## MEMORANDUM

**TO:** Shutesbury Conservation Commission

**DATE:** January 26, 2024

**RE:** Shutesbury Public Library Notice of Intent (MassDEP File No. 286-0304)  
Supplementation Information

Sheet No.:  
**P1.01**

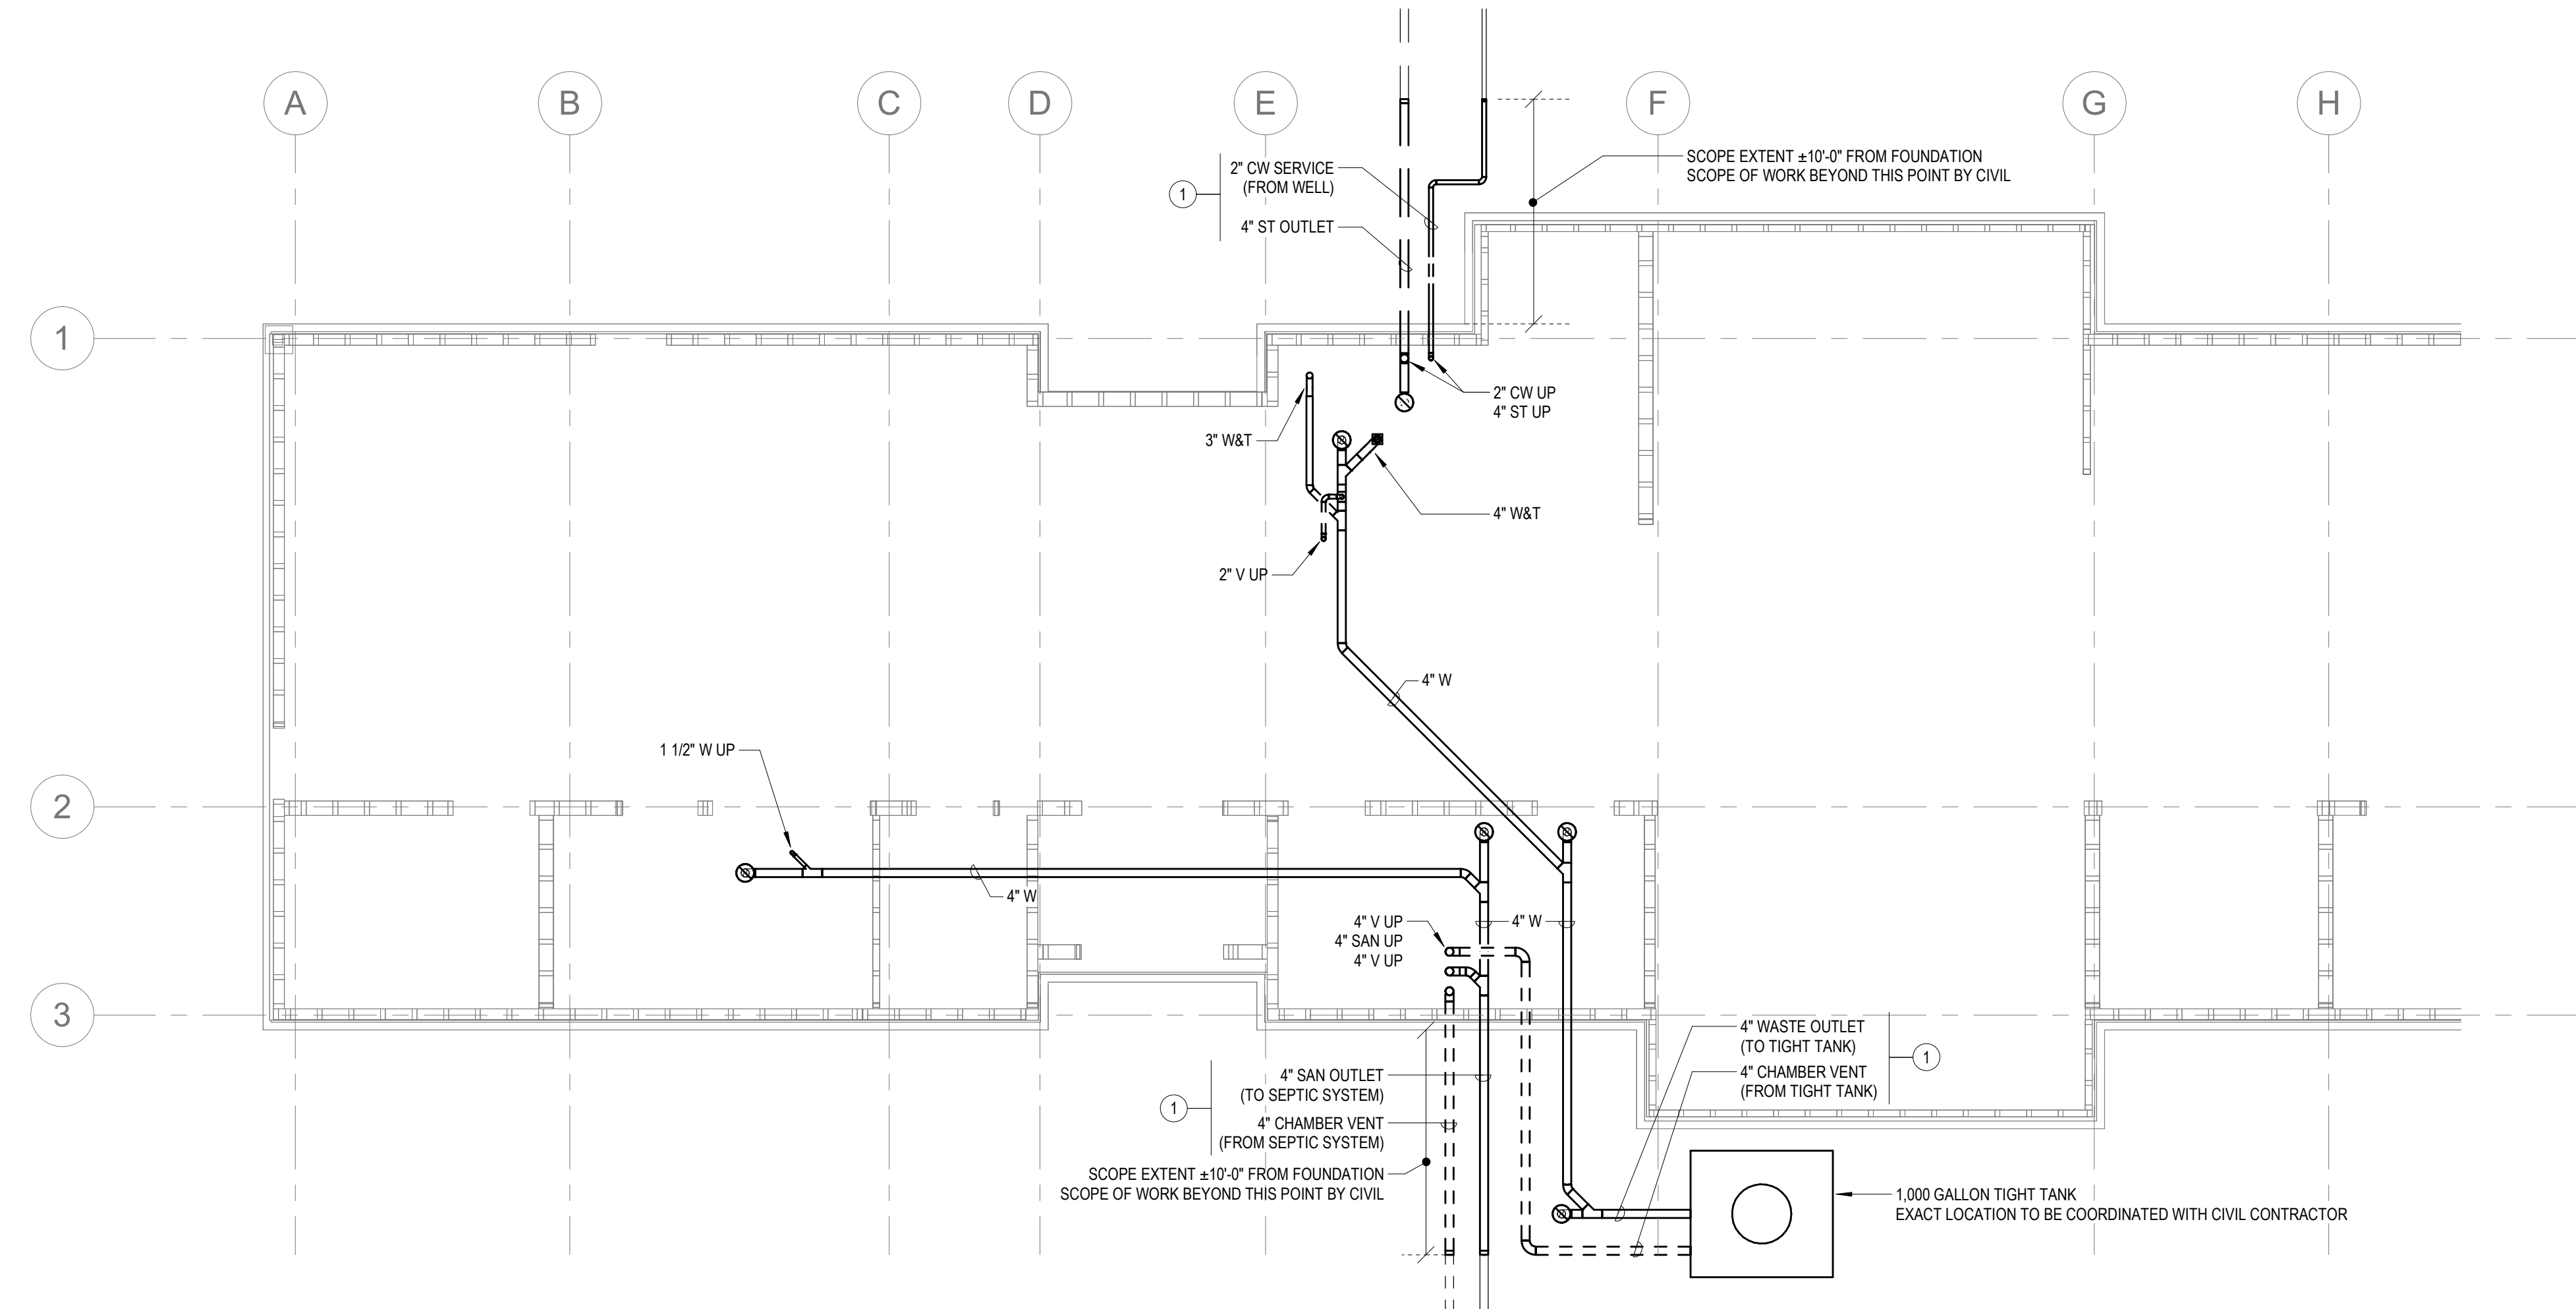
*Shutesbury Conservation Commission Comment [4]: Can you clarify information on the tight tank?*

As part of the Shutesbury Library design, a tight tank is included in addition to the traditional septic system. A tight tank works as a containment unit for waste that cannot safely be processed by the septic system either causing damage to the septic system or potentially leeching undesired contaminants into the groundwater.

Massachusetts code dictating the proper installation and use of tight tanks come from the Department of Environmental Protection, 310 CMR: 15.260. It is important to note that the use of tight tanks is expressly discouraged, and Massachusetts plumbing code requires that all other available options be exhausted before a tight tank be utilized/installed. In typical operation, when the tank reaches a high-water level it will alarm allowing the Owner to coordinate proper maintenance. In the design for the Shutesbury Library, a tight tank has been proposed because wastewater from floor drains and the janitor's closet mop receptor are a concern for the septic system. The drainage piping associated with these sources is entirely independent of the drainage piping associated with the septic system and would be considered a dedicated system. A high-water alarm would be included in the design and recommendation for maintenance schedule would be part of the specification.

The next step from this point forward is to review the dedicated waste system with the septic designer to make the final determination as to whether there is a concern regarding the mop receptors and/or floor drain(s). Subsequently the intended design approach must be reviewed with the local authority to ensure it meets their approval.

Please refer to the plumbing drawing P1.01 describing the tight tank as independent to the septic system.
